PLANNING MANAGER DECISION

DATE: June 25, 2020

FILE NO.: WAP-20-01/WRG-20-01/MIS-20-01/LLA-20-01

REQUEST: Request for a Water Resource Area permit, a Willamette River Greenway permit, and a Flood Management Area permit to construct a new single-family home on Tax Lot 802 of Clackamas County Assessor Map 31E 02AC. The request also includes a Property Line Adjustment between Tax Lots 802 and 800 of Clackamas County Assessor Map 31E 02AC.

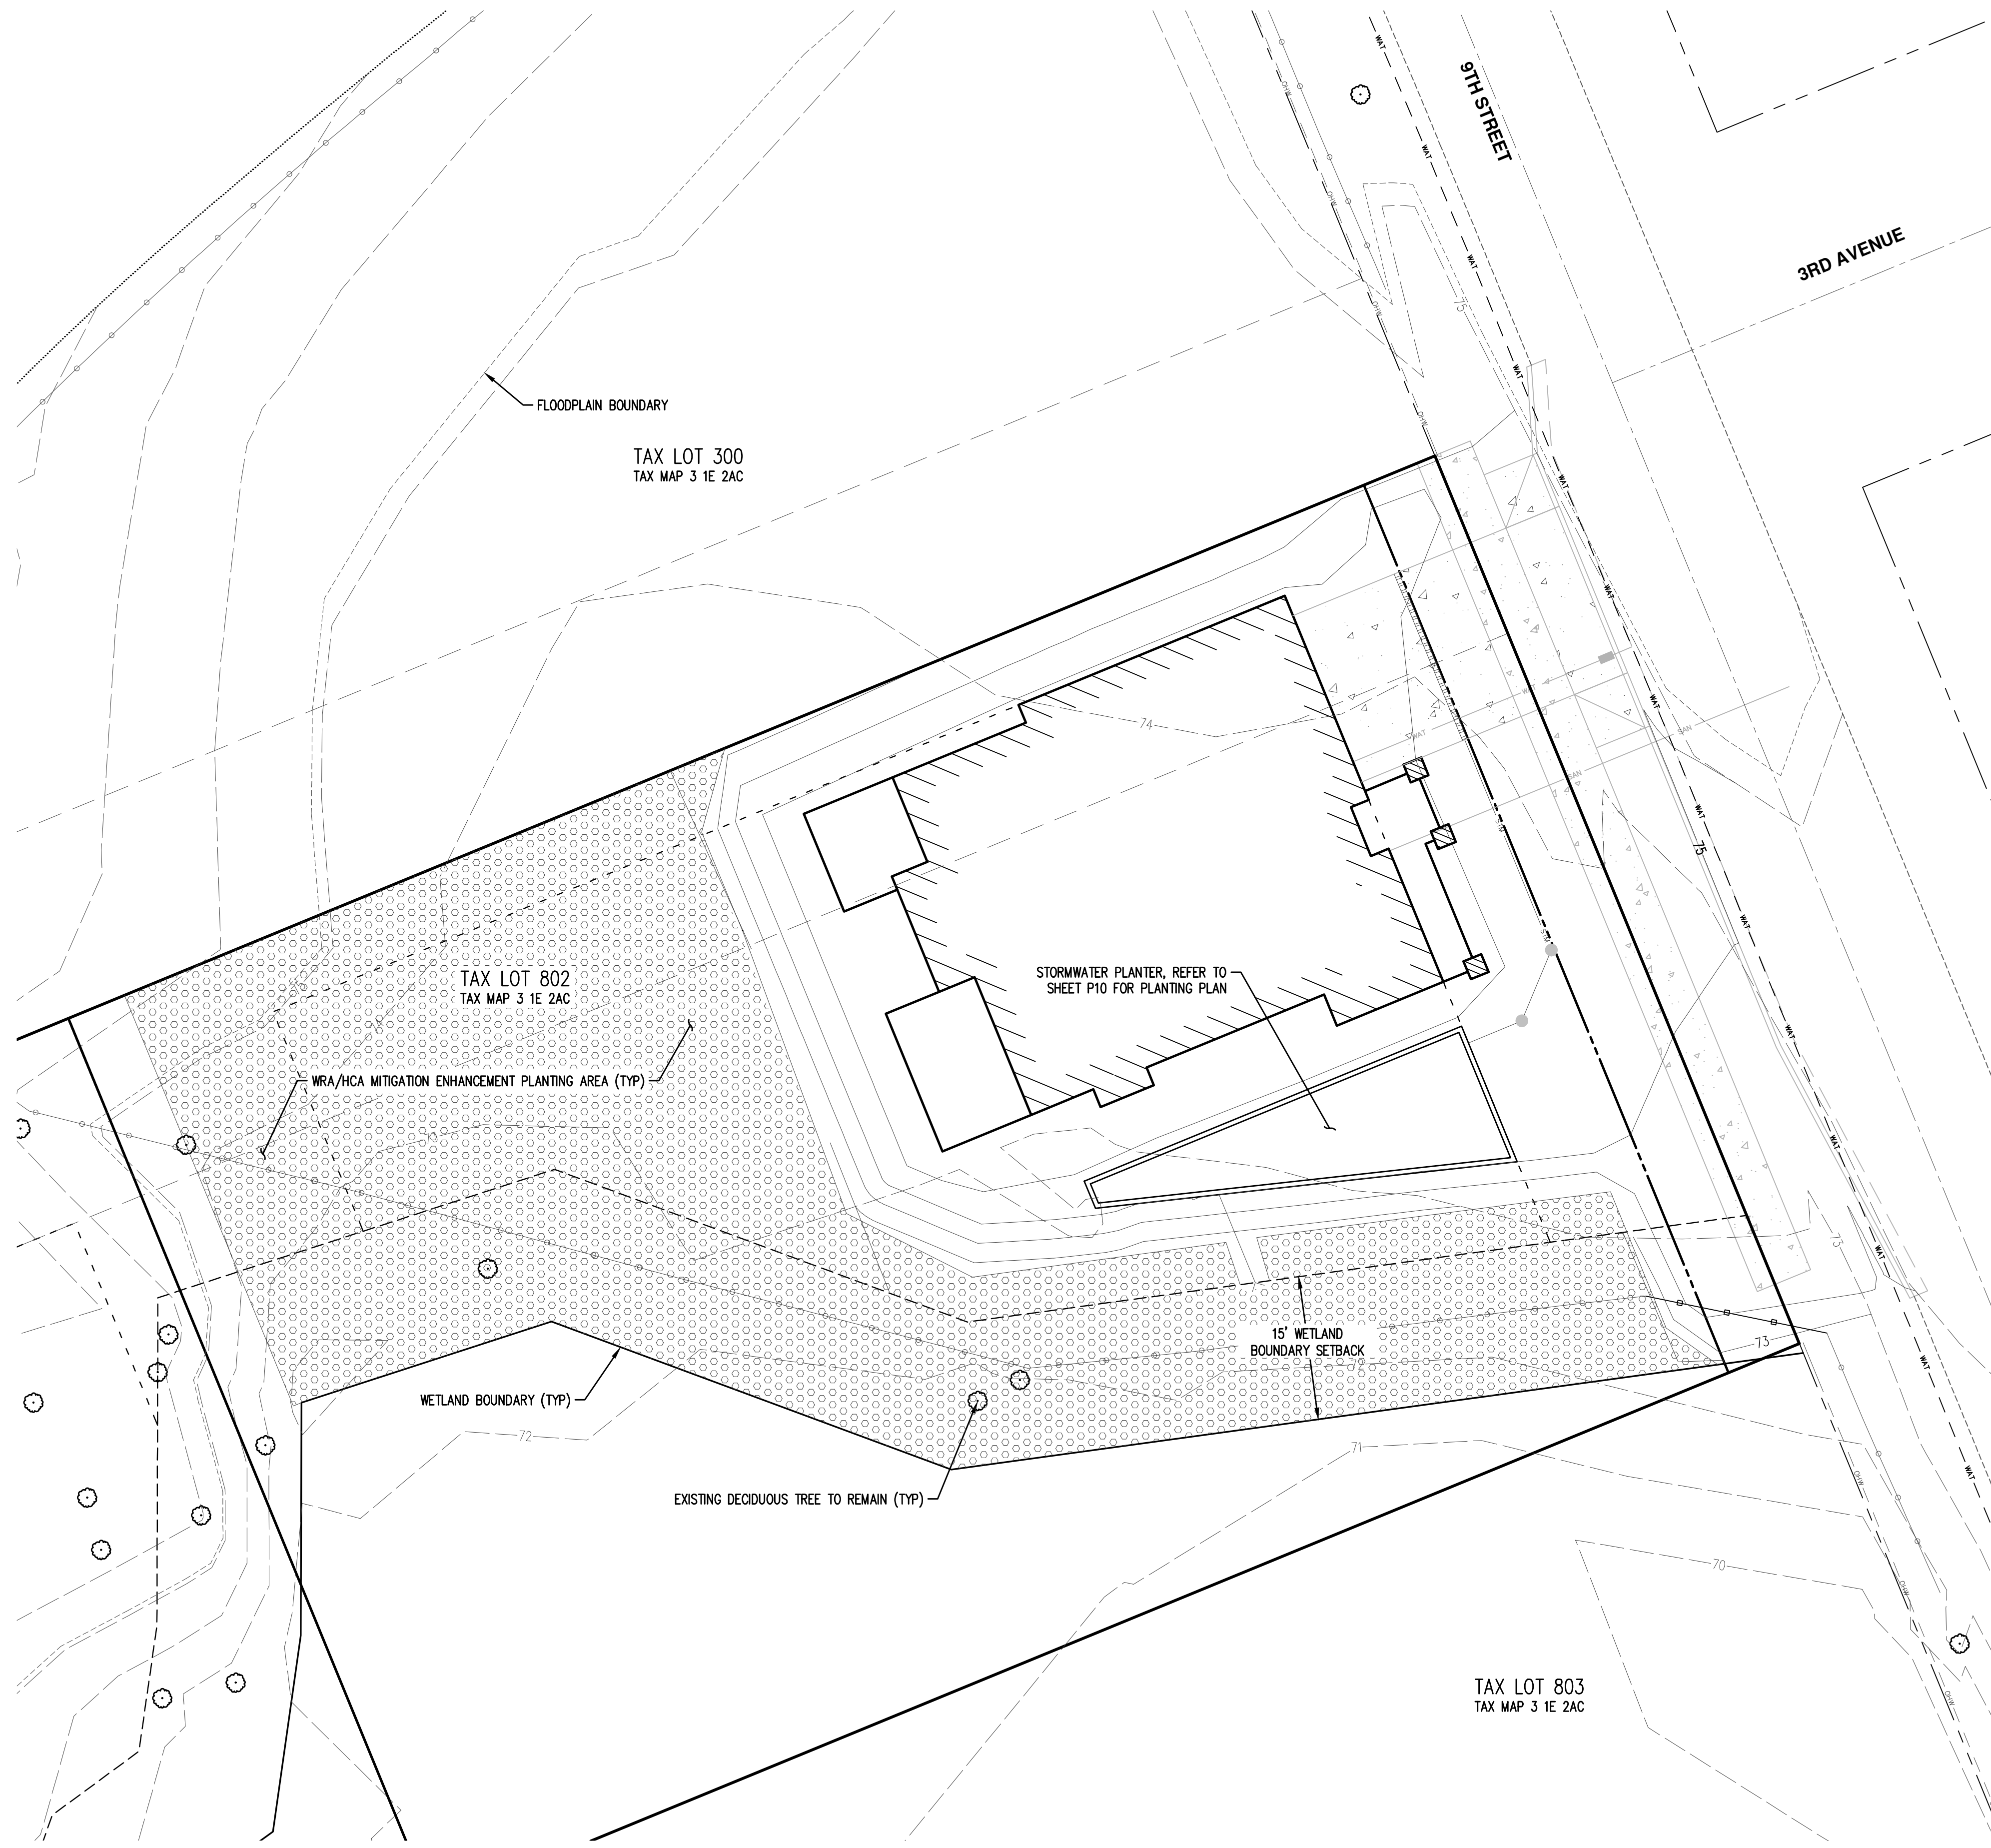
Staff Finding 36: The applicant proposes to restore all Temporarily Disturbed Areas to pre-construction conditions and planted with native plants per Plan Sheet P11. All non-restored areas have been included in the proposed 3,588 square foot MDA. The criteria are met.

Staff Finding 44: The applicant proposes to restore TDAs with native vegetation. The subject property is completely encumbered by the WRA that has been assessed in the submitted Site Assessment Report performed by AKS and found in Exhibit PD-1, pages 275 to 348. The proposed re-vegetation plan can be found as Plan Sheet P11 in Exhibit PD-1. The criteria are met.

Staff Finding 45: The subject property is completely encumbered by the WRA that has been assessed in the submitted Site Assessment Report performed by AKS and found in Exhibit PD-1, pages 275 to 348. The applicant proposes on-site mitigation per Plan Sheet P11 in Exhibit PD-1. The criteria are met.

Staff Finding 46: The applicant proposes to restore on-site TDAs with native vegetation. The subject property is completely encumbered by the WRA that has been assessed in the submitted Site Assessment Report performed by AKS and found in Exhibit PD-1, pages 275 to 348. The applicant proposes to mitigate the 3,588 square foot PDA with 5,000 square feet of on-site mitigation per Plan Sheet P11 in Exhibit PD-1, meeting the requirements. The criteria are met.

FOUNDATION PLAN
 SCALE: 1/4" = 1'-0"

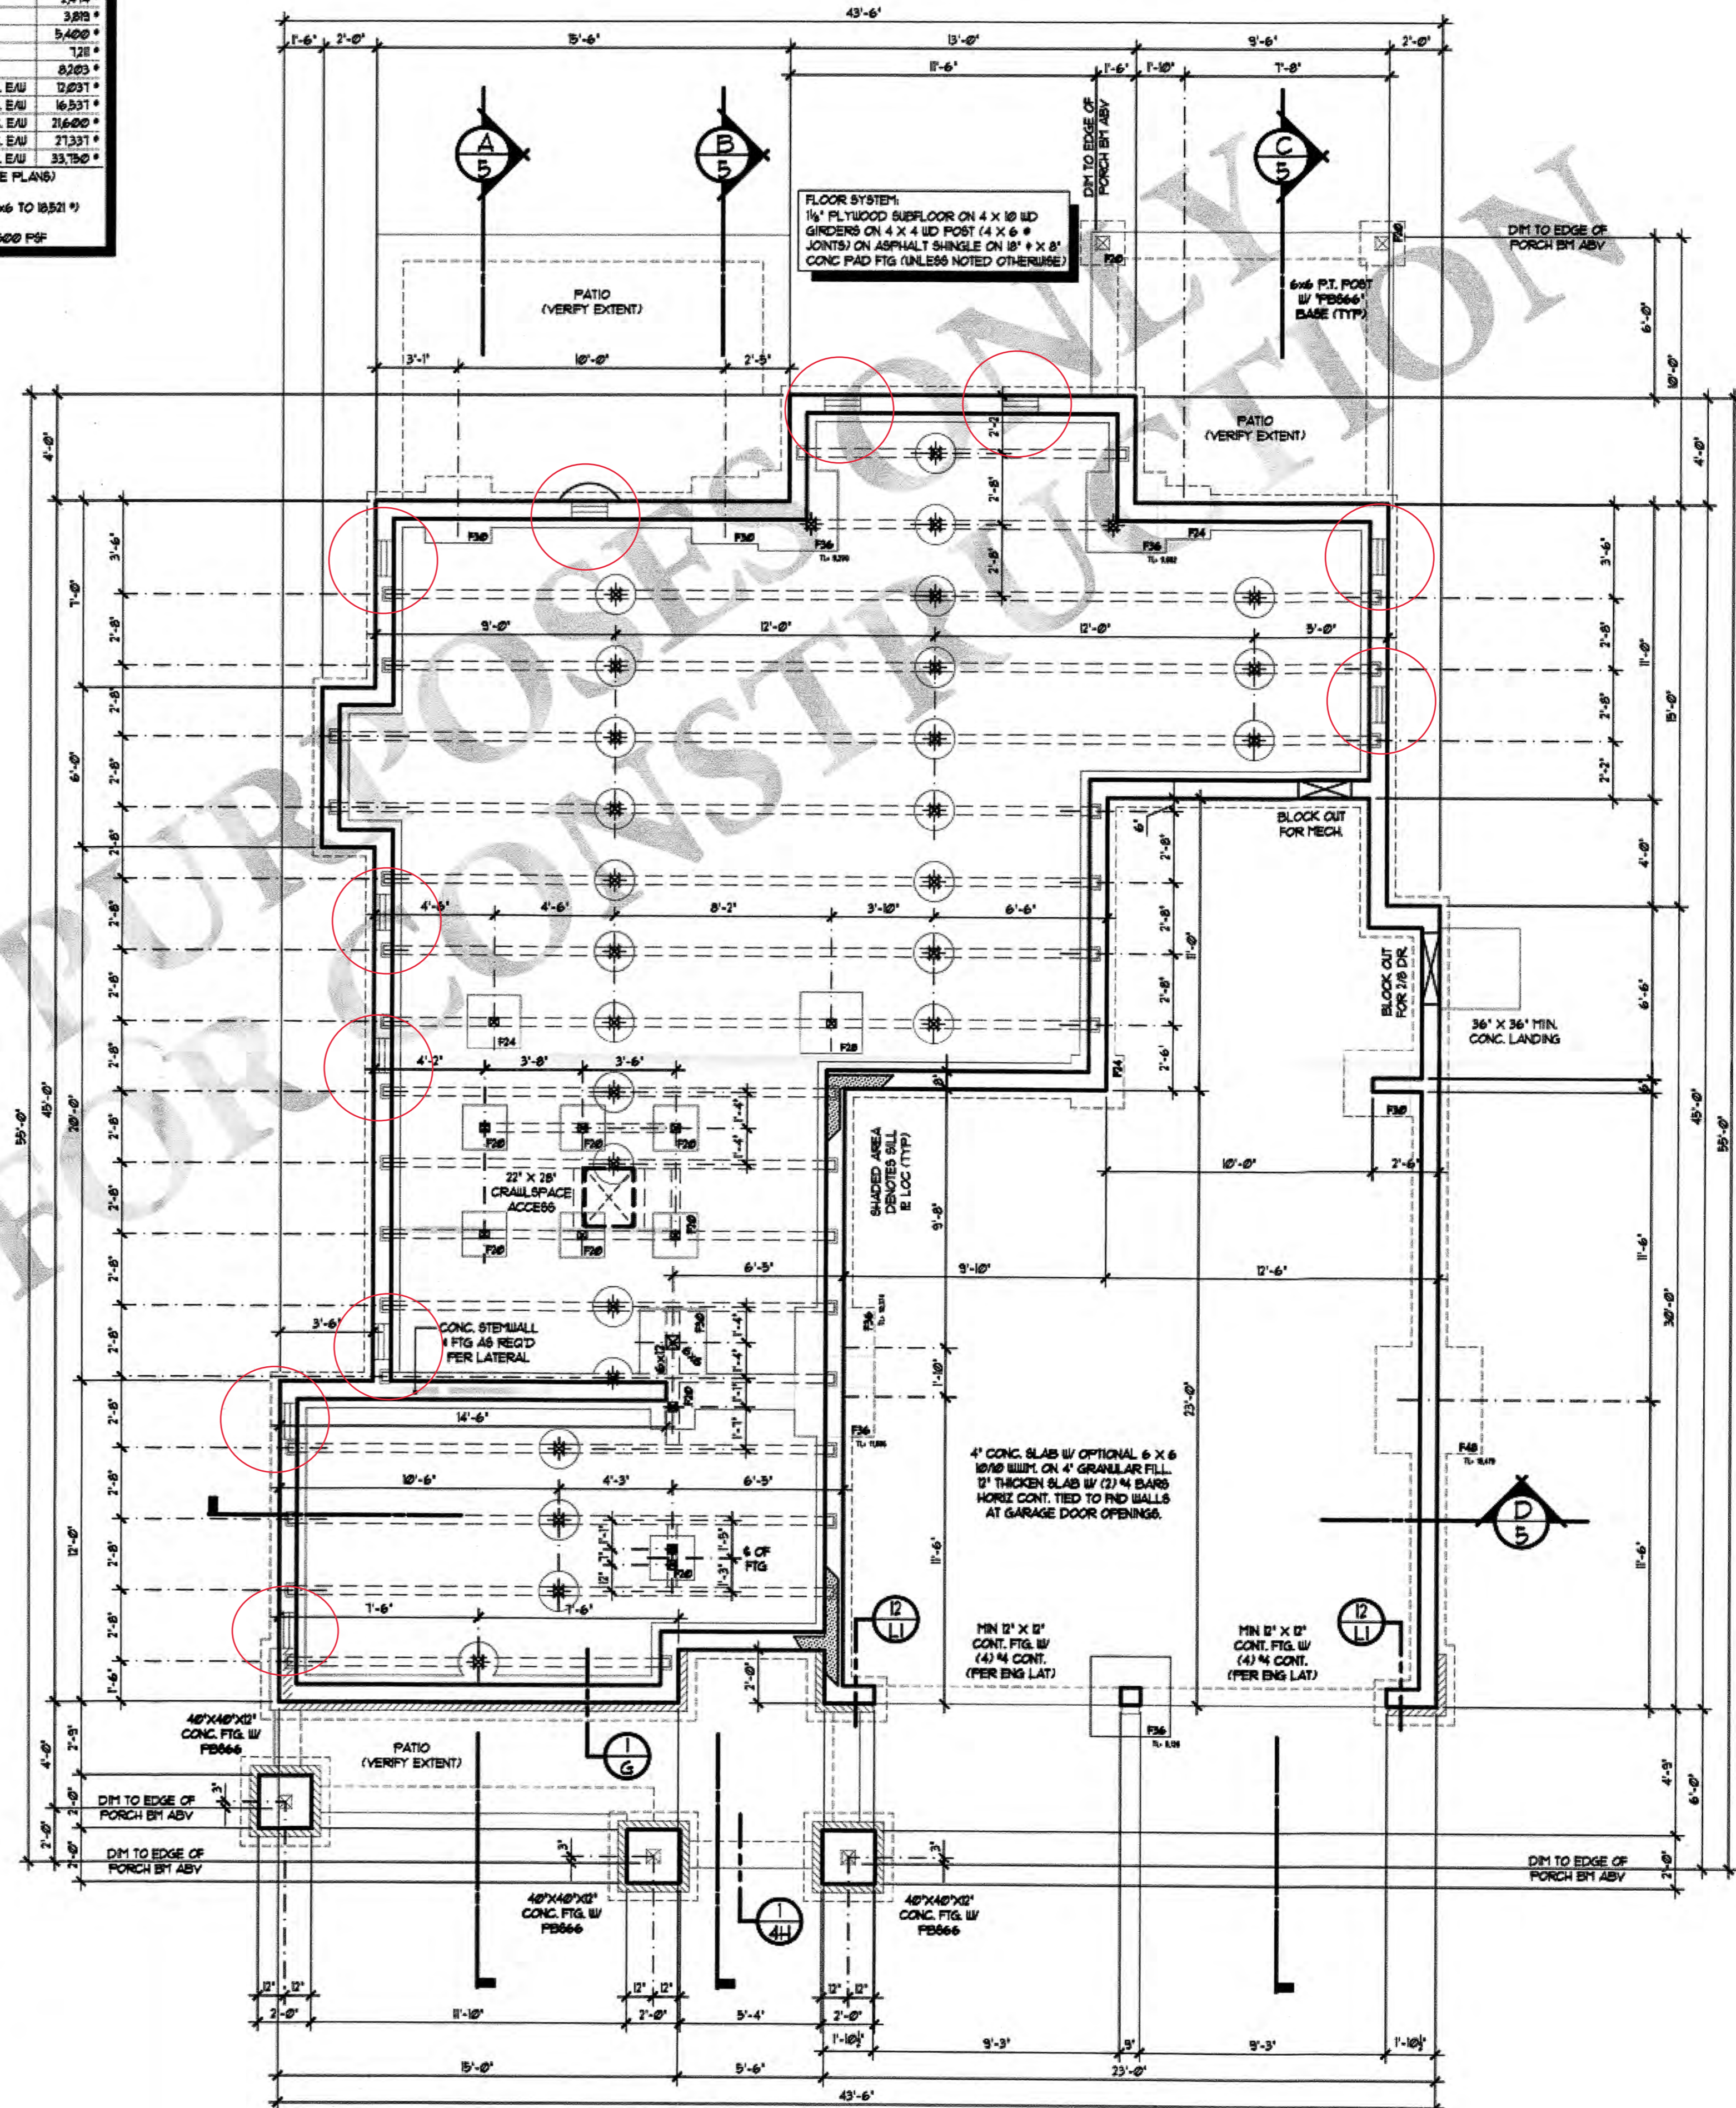
Staff Finding 19: The applicant has submitted a conceptual foundation plan, but final design has not been completed. The applicant shall submit final construction plans showing elevation of interior grade of a crawlspace, the adjacent exterior grade, the height of the crawlspace, and an adequate drainage system per Condition of Approval 8. Subject to the Conditions of Approval, the criteria are met.
